29<sup>th</sup> February 2012

Formal submission in response to:

**The Cardno/Landcorp Structure Plan & Report (P11002) of December 2011.**

*Precinct Plan*

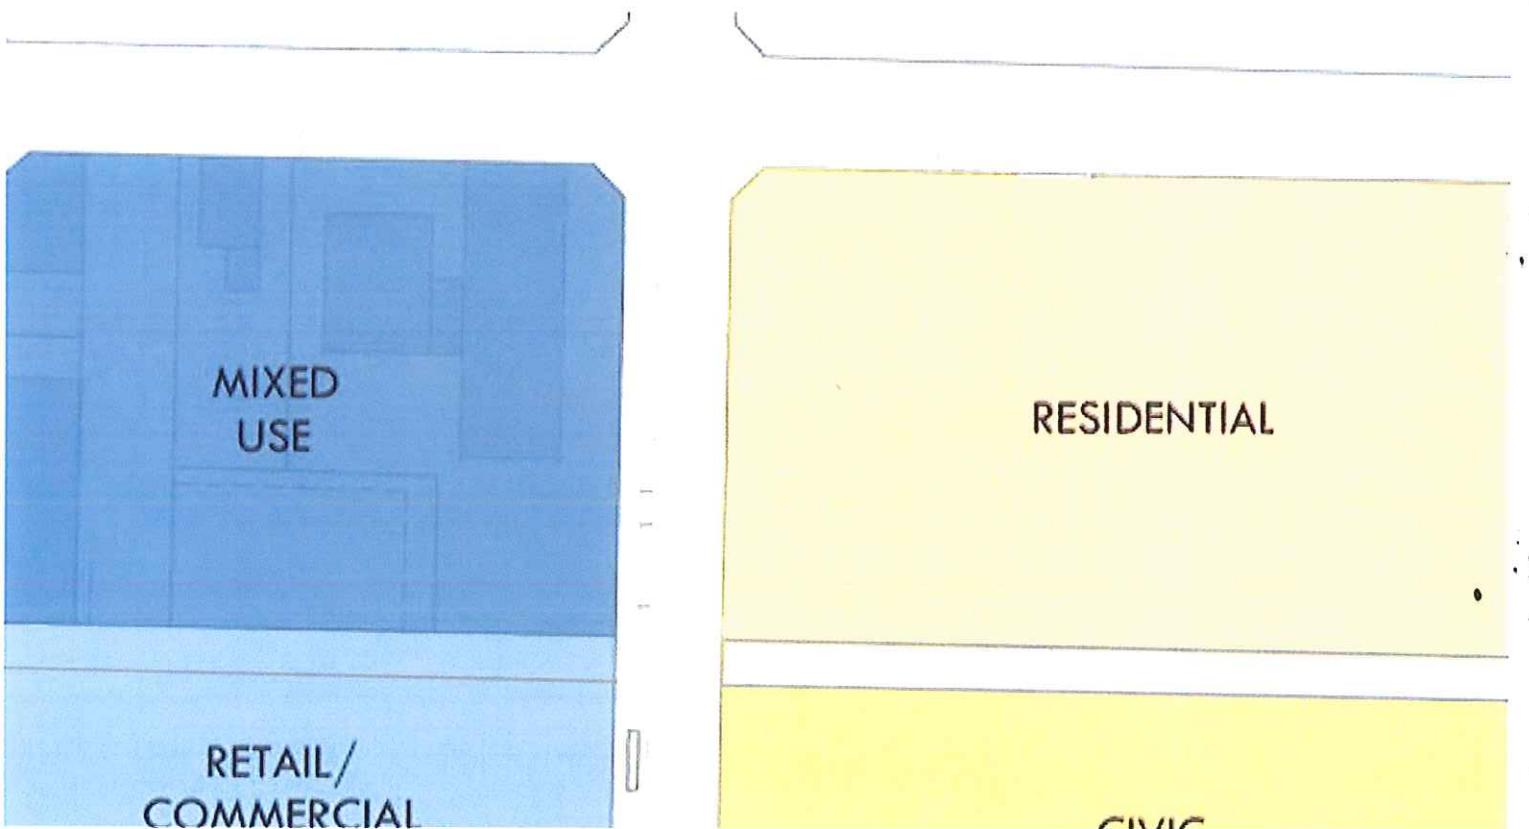
PROPOSAL - ROTATE CIVIC AND RESIDENTIAL 90 DEGREES: 'MAIN STREET' AND ACHIEVE 'EXPOSURE' OBJECTIVES AND VIEWS FROM CIVIC AREA.

3. Rotate and move the residential precinct to run N-S between Garnett Rd and the Civic precinct as shown on page 9.
4. Orientate the Civic Centre site along the main street and locate it close to and upon the 24 metre contour so as to capitalize on views to the FRNP estuary, John street shrubland and the existing town site. Doing so will aid in the activation of the main street (page 9)

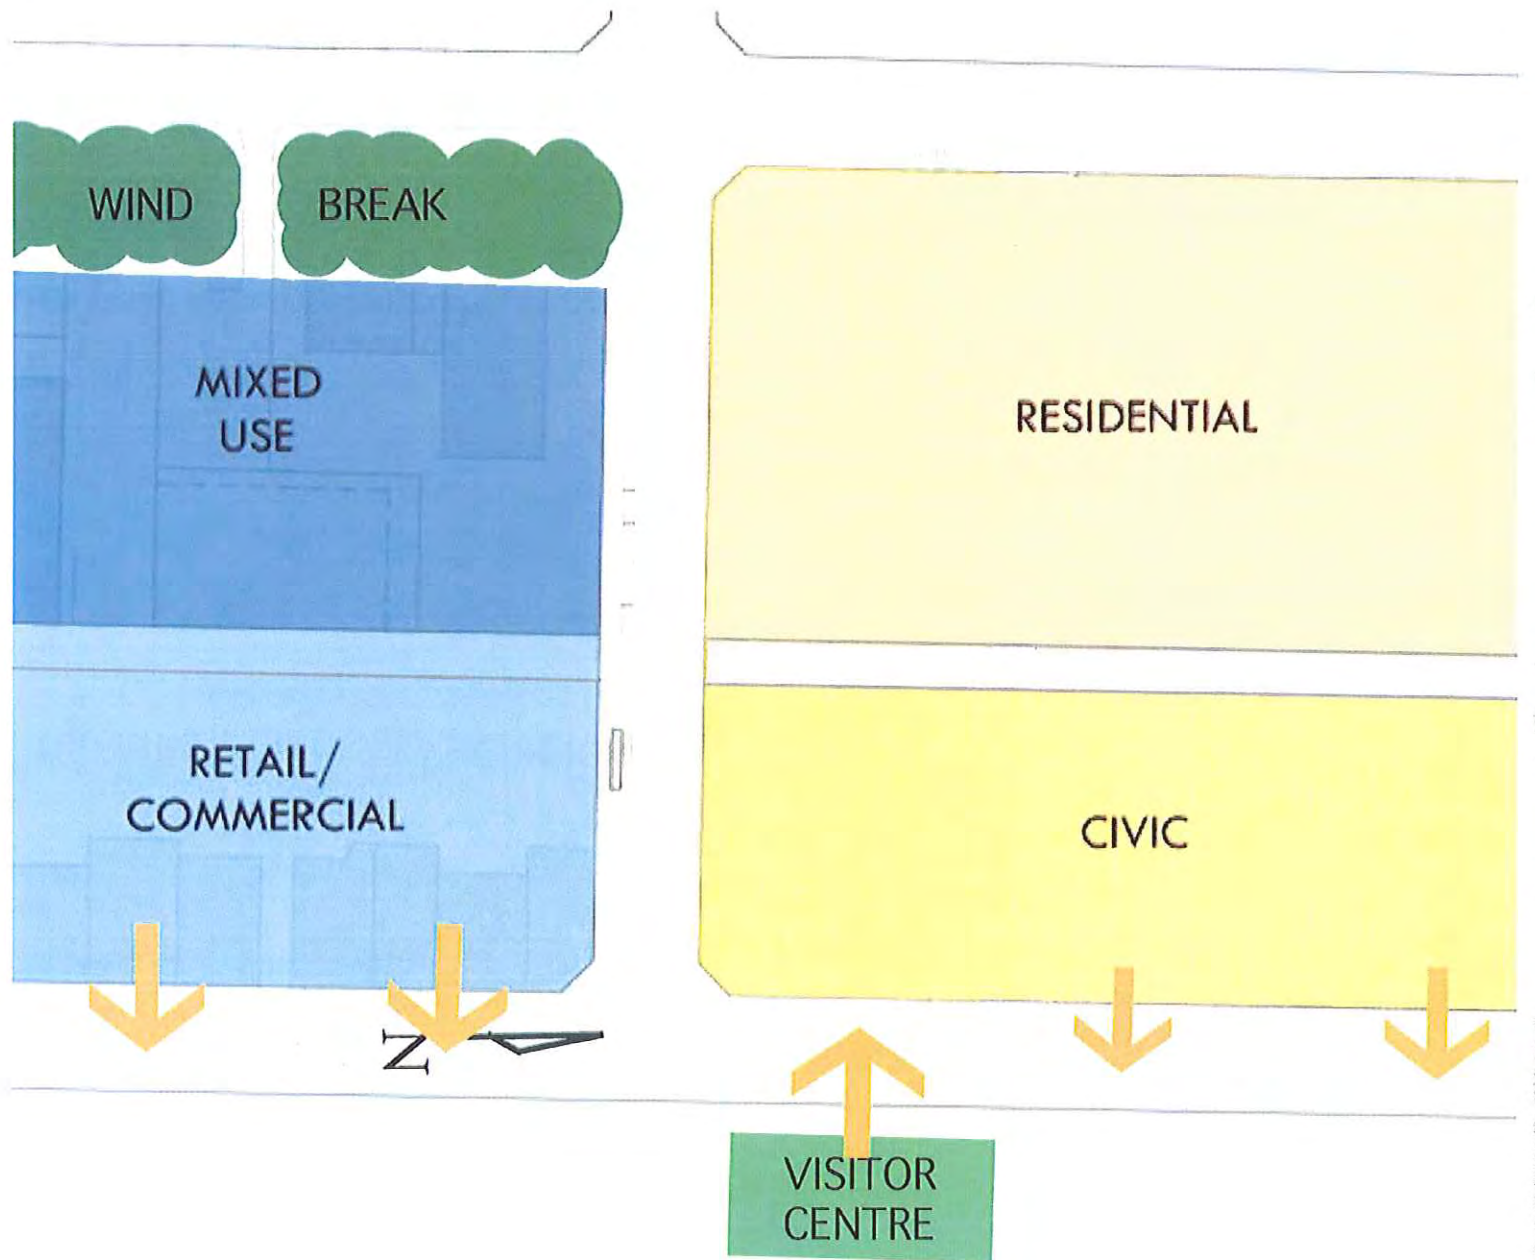
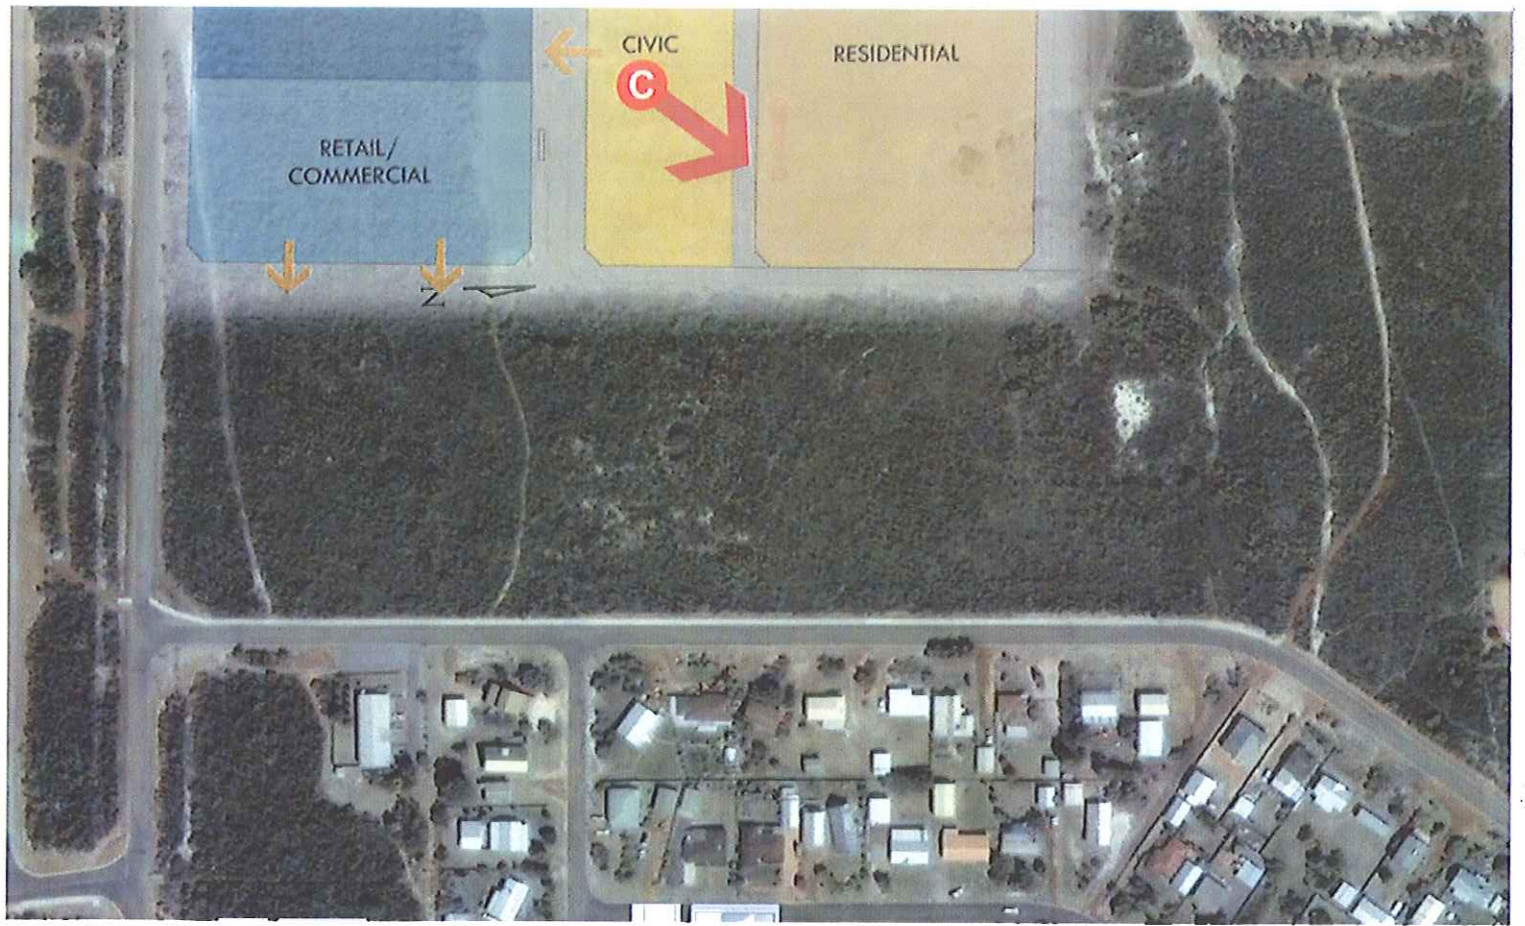
2. Views of the greater landscape and town site are best gained from the 24 m contour which is at the same elevation as the primary school. Our photographs on page 11 show that from this contour the landform 'drops away' to reveal the town site, and estuary below, along with the FRNP mountains in the background.

# EXISTING VEGETATION STRIP ALONG GARNETT ROAD D BREAK.

6. Make Gnombup Tce two-way for its entirety so as to ensure growth in this area.
7. Provide for greater protection of shrubland along Garnett Rd so as to provide a necessary wind break to residential and commercial precincts.

# O PLAN: ZONING DIAGRAM SUPERIMPOSED ON AERIAL PHOTO

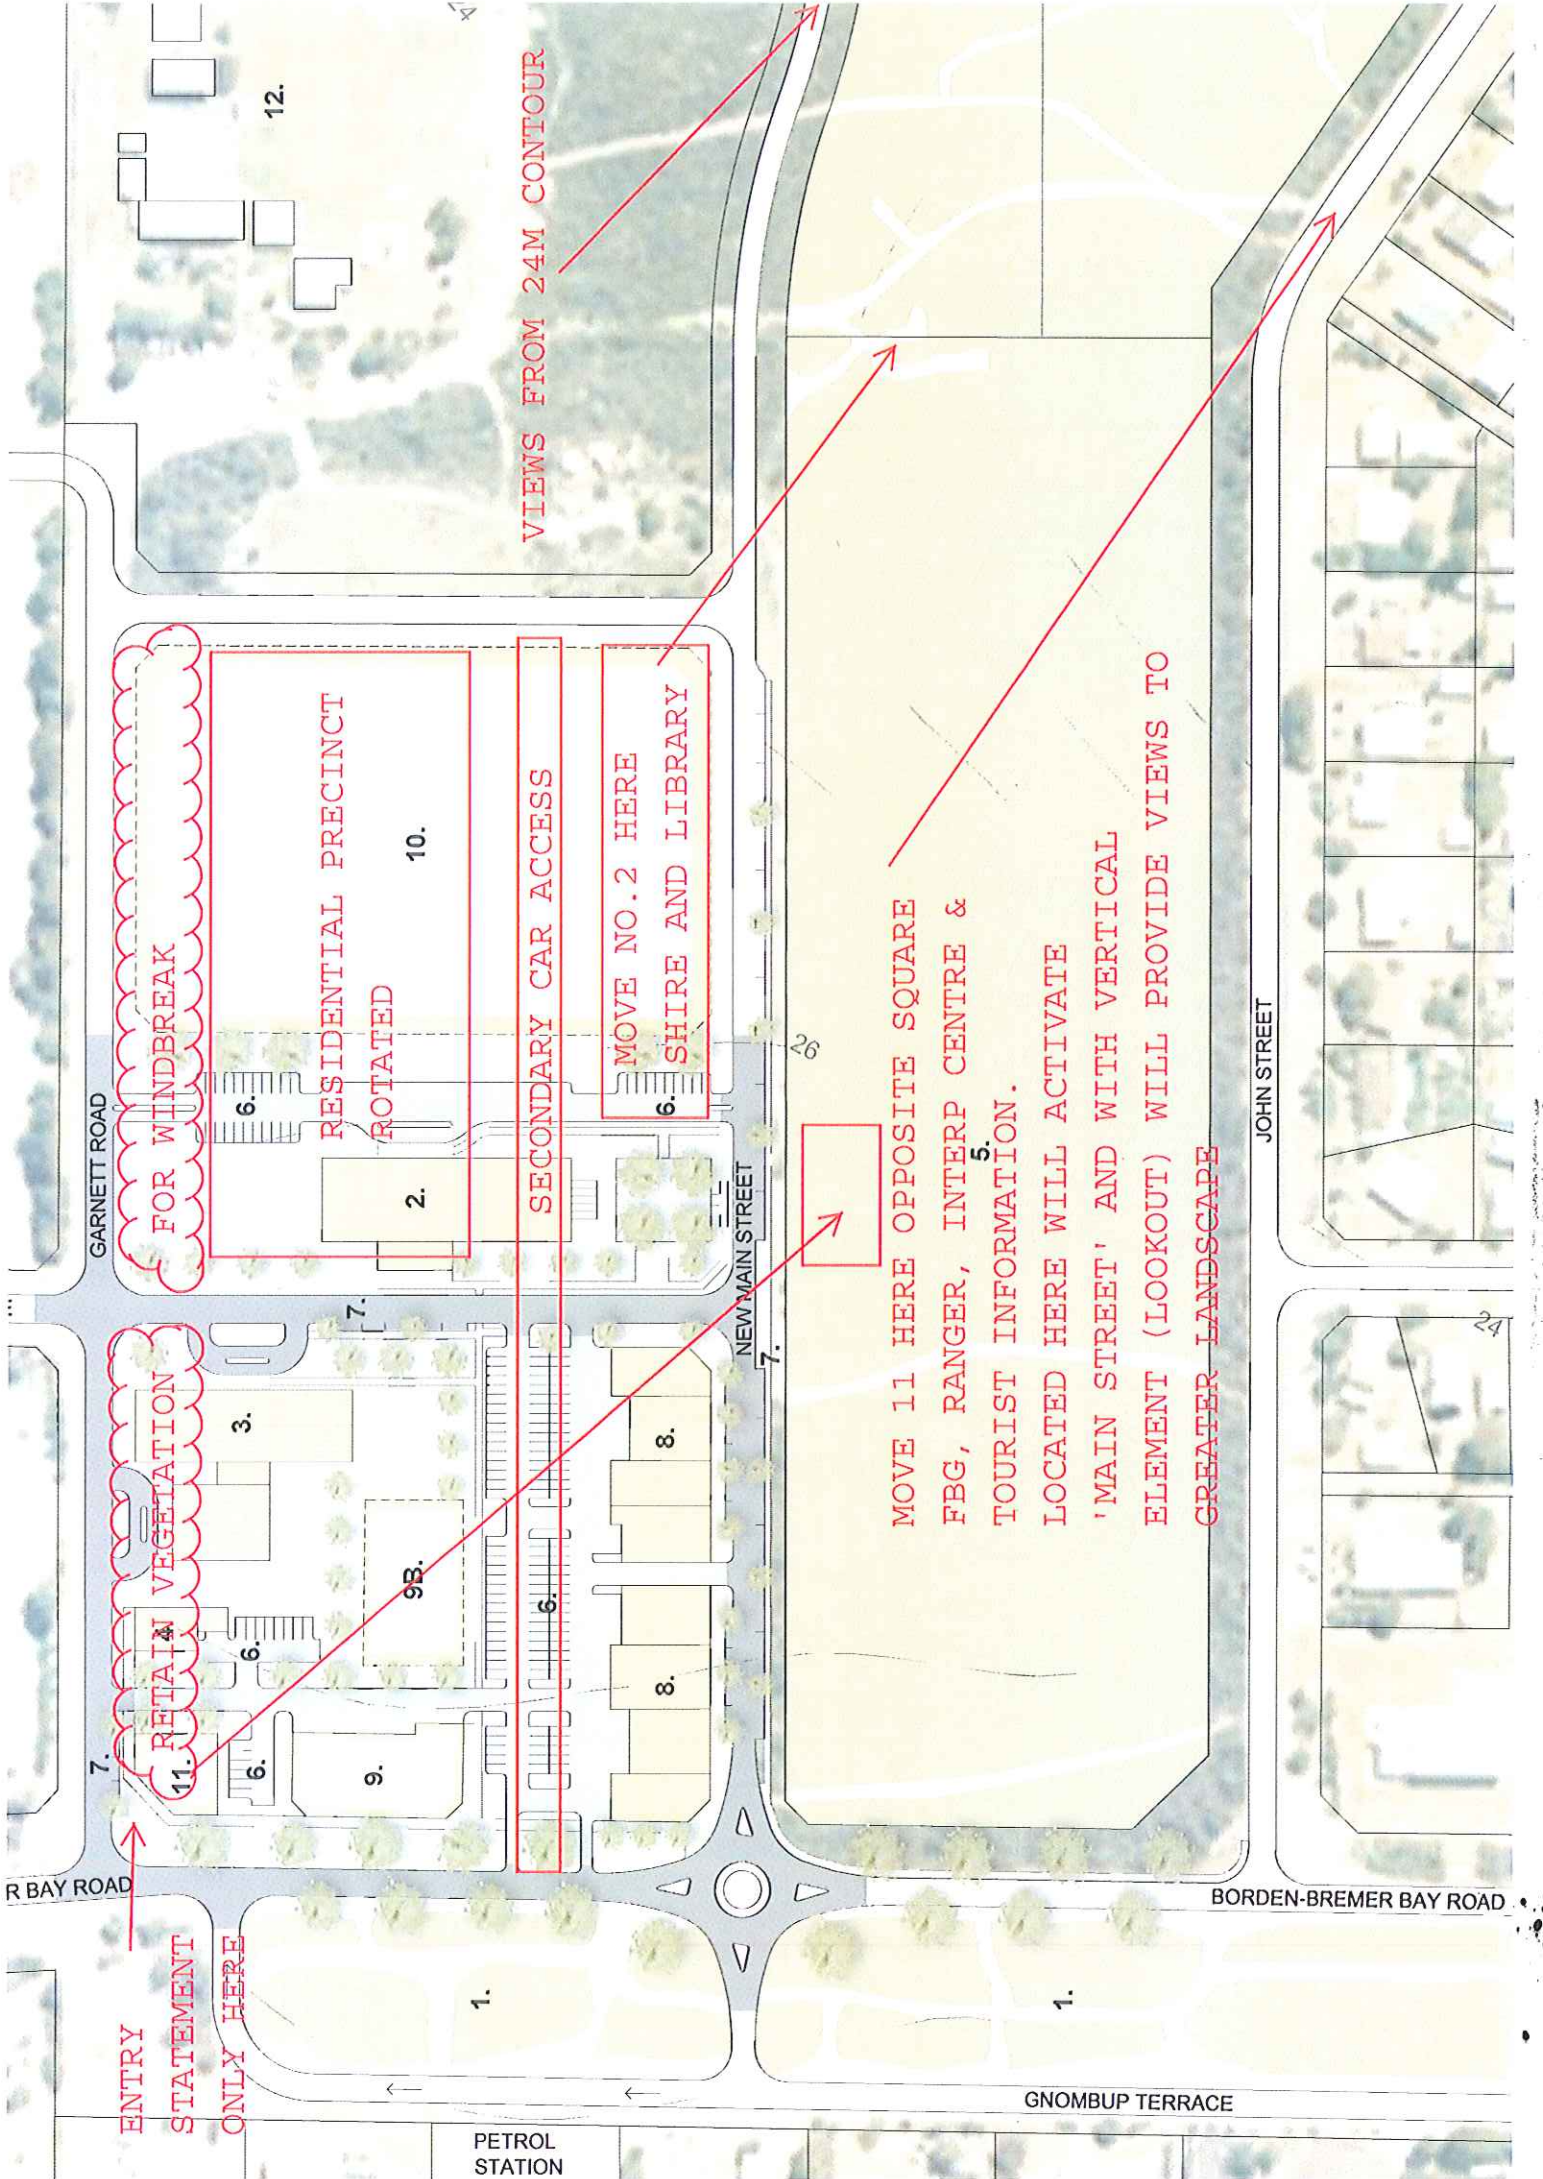
ENTRY STATEMENT ONLY HERE

11. RETAIN VEGETATION

FOR WINDBREAK

RESIDENTIAL PRECINCT ROTATED

MOVE NO.2 HERE SHIRE AND LIBRARY

MOVE 11 HERE OPPOSITE SQUARE FBG, RANGER, INTERP CENTRE & TOURIST INFORMATION. LOCATED HERE WILL ACTIVATE 'MAIN STREET' AND WITH VERTICAL ELEMENT (LOOKOUT) WILL PROVIDE VIEWS TO GREATER LANDSCAPE

VIEWS FROM 24M CONTOUR

2. The future visitor centre should be relocated to the heart of the town centre and sited within the mallee/banksia shrubland to provide direct engagement with the landscape – in doing so this will create the necessary activation of the main street. The argument for biological interconnectedness should not exclude human activity because interconnectivity is itself a fundamental tenet of the Biopshere Reserve - of which Bremer Bay is a landmark exemplar. On page 14 we present are concept idea of the visitor centre as a 'semi transparent' structure that frames the mallee/banskai shrubland and greater landscape.

5. Locating the visitor centre where we propose – presents the opportunity for a vertical structure – lookout – to view directly down to the existing town centre. This visual link should be supported with a dual use path linking the two sites – thus aiding in the evolution of the Town Centre from stages 1 through to 3 (page 11)

10. Entry statements: Do not have two in the town centre – have one at the roundabout to help with stage 1 implementation of the retail area and have one on the outskirts of town indicating that visitors are about to arrive and thus signal the 'slowing down and looking' process.
